Access Compliance Report

Public Rights-of-Way

(Curb Ramps)

Intersection ID: 47912	Main Street: MOUNTAIN_QUAIL_DR	Cross Street: MEARN_RD	Location: S
ADA ID: E241EA20A215	Ramp Type: PerpDiag	Initial Pass/Fail: Fail	Overall Compliance: No
			Severity Score: 21.25

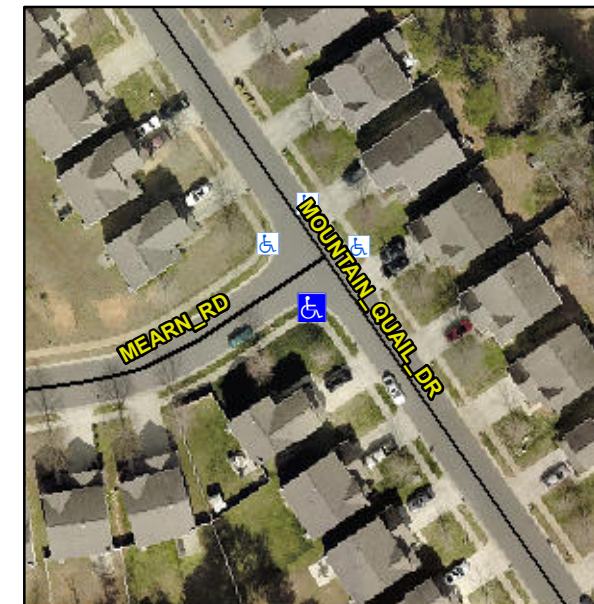
Not Found, R304.5.1, R304.2.2

Compliance	Description	Data	Compliance	Description	Data
N/A	Ramp Length (in)	51.0	No	Ramp Slope (%)	9.2
No	Ramp Width (in)	38.5	Yes	Ramp XSlope (%)	0.8
N/A	Flare Type LT	N/A	N/A	Flare Type RT	N/A
N/A	Flare Slope LT (%)	N/A	N/A	Flare Slope RT (%)	N/A
N/A	Flare Traversable LT?	N/A	N/A	Flare Traversable RT?	N/A
N/A	Landing Length (in)	N/A	N/A	DWS Provided?	N/A
N/A	Landing Width (in)	N/A	N/A	DWS Contrast?	N/A
N/A	Landing Slope (%)	N/A	N/A	DWS Length (in)	N/A
N/A	Landing X Slope (%)	N/A	N/A	DWS Full Width?	N/A
N/A	Landing Curb? (Y/N)	N/A	N/A	DWS Offset (in)	N/A
N/A	Shared Landing?	N/A			
N/A	Gutter Ponding?	N/A	N/A	Gutter Slope (%)	N/A
N/A	Gutter Lip Ht (in)	N/A	N/A	Gutter X Slope (%)	N/A
N/A	Painted X Walk1?	No	N/A	Painted X Walk2?	No
	X Walk 1 Direction	To E		X Walk 2 Direction	To NW
N/A	X Walk 1 Width (in)	N/A	N/A	X Walk 2 Width (in)	N/A
	X Walk 1 Slope (%)	2.8		X Walk 2 Slope (%)	0.9
	X Walk 1 X Slope (%)	1.9		X Walk 2 X Slope (%)	0.8

Remove & Replace Curb Ramp With Two New Directional Ramps or Equivalent.
